Memorandum

SUBJECT U.S. Department of Health & Human Services, Request for Additional Information
Concerning Application for a License Amendment, Control 588982591780 *amy*

10-06772-01
03004001

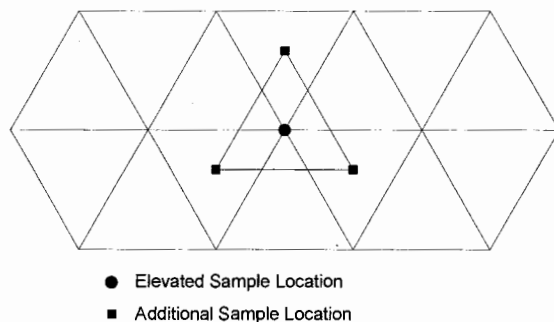
3. Sample 1 of Survey Unit 4 survey results for loose surface contamination results are 23.8 dpm/100 cm² alpha which is above the DCGL for alpha per License Condition 20. No discussion or follow up of the survey was presented, nor was it noted as being above the DCGL. Please re-perform surveys in this area to determine size of the contamination and if the area can be cleaned up. Please present further documentation to why this area may be released.

We believe the results provided were converted incorrectly. The original removable results were calculated from the straight 4-pi efficiency of the Protean instrument utilized. To use the ISO-7503-1 Standard from an instrument calibrated with 4-pi efficiency, the efficiency must be doubled to simulate the 2-pi efficiency normally utilized in the ISO-7503-1 Standard, prior to the application of the surface efficiency of 25%. Therefore, using this methodology, actual results are half of those presented and are now accurately presented in Appendix G as 11.9 dpm/100 cm², and not 23.8 dpm/100 cm² originally reported. Longer count times, although not required to meet the DQOs, may have eliminated the problem, as the removable DCGL was at the lower

In addition, all total activity (fixed plus removable) results were less than 15 dpm/100 cm², indicating the removable results were not actually the 23.8 dpm/100 cm² and were likely statistical noise from acquiring 2 counts on the Protean while running the removable smears. As such, all total activity results were less than ten percent of the total activity DCGL for all alpha measurements; therefore, removable activity measurements were likely not even required.

However, in the interest of providing the requested documentation, all survey locations provided in the original FSSR with results in excess of the DCGL were investigated. Additional samples collected for investigation purposes were collected at locations that support the original random-systematic pattern used in the original survey design. For any original sample location where original activity was reported in excess of the DCGL, in addition to resample of the original location, an additional three samples were collected. A triangular grid, using the same sample spacing as the original survey was superimposed using the location of the elevated activity as the center. The additional samples were collected at the corners of the grid and were analyzed using the same instrument as the original samples. An example of sample design is provided below.

Maximum removable activity was 5.6 dpm/100 cm².
